# 802.3df D1.1

# Comment Resolution

P802.3df editorial team

Figure 173-3—32-R PMA functional block diagram

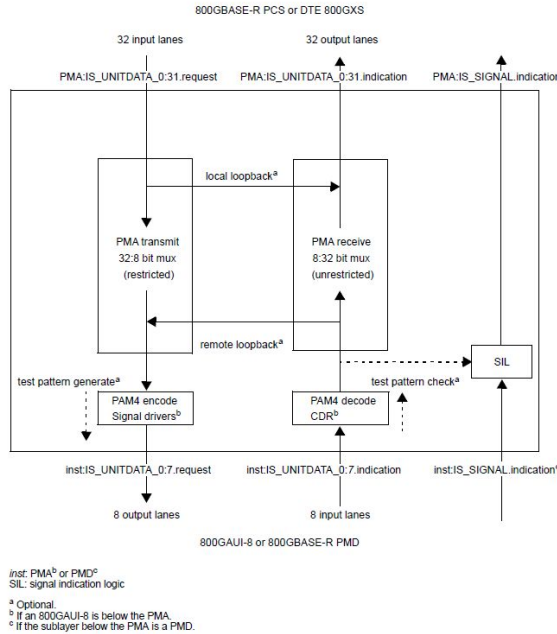
PMA:IS\_UNITDATA\_0:31.request would be better shown as PMA:IS\_UNITDATA\_0:15.request and PMA:IS\_UNITDATA\_16:31.request as in Figure 172-2. The PMA doesn't really know lane numbers, it doesn't read alignment markers, but it needs to know the two groups to apply the restricted bit muxing rules. The output lanes can stay as one group.

Show two groups of 16 input lanes, PMA:IS\_UNITDATA\_0:15.request and PMA:IS\_UNITDATA\_16:31.request. Similarly for the 32 PHY\_XS:IS\_UNITDATA\_0:31.indication lanes in Figure 173-4, 8:32 PMA functional block diagram.

PROPOSED REJECT.  
 There are 32 PCS lanes represented by PMA:IS\_UNITDATA\_0:31. Figure 172-2 shows the two groups, one from 0:15 and the other from 16:31, to show how the lanes from each flow map to the set of 32 PCS lanes. Showing the separation of the two groups of lanes in this PMA diagram is not helpful. Since the PMA is connected directly to the PCS (colocated), the lane numbers are known by the PMA.

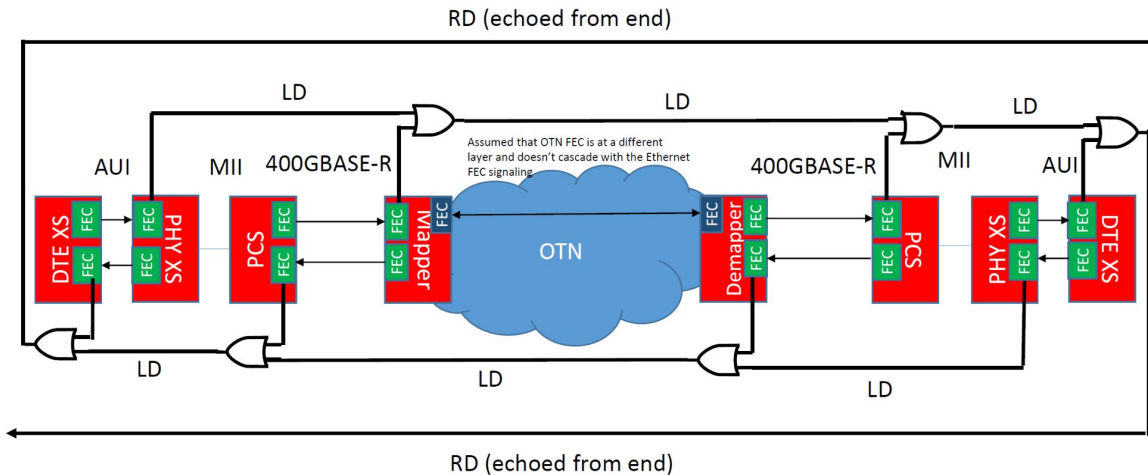
In Table 172-4, row 3, column "R\_TYPE (rx\_coded\_i)", the value is "S or D or T or C".

The possible R\_TYPE values (based on 119.2.6.2.3) are C, LI, S, T, D, and E; LI is not valid for clause 172 (per 172.2.3, EEE and low power idle are not supported). Therefore, "S or D or T or C" is equivalent to "not E". This excludes only the combination "E | E".

However, the combination "E | E" matches the second row, and therefore results in the same rx\_raw, EBLOCK\_R. So having R\_TYPE(rx\_coded\_i-1)=E with any value of R\_TYPE(rx\_coded\_i) would result in EBLOCK\_R.

This means the table can be simplified and made more readable.

"0 | E | any block type | EBLOCK\_R".
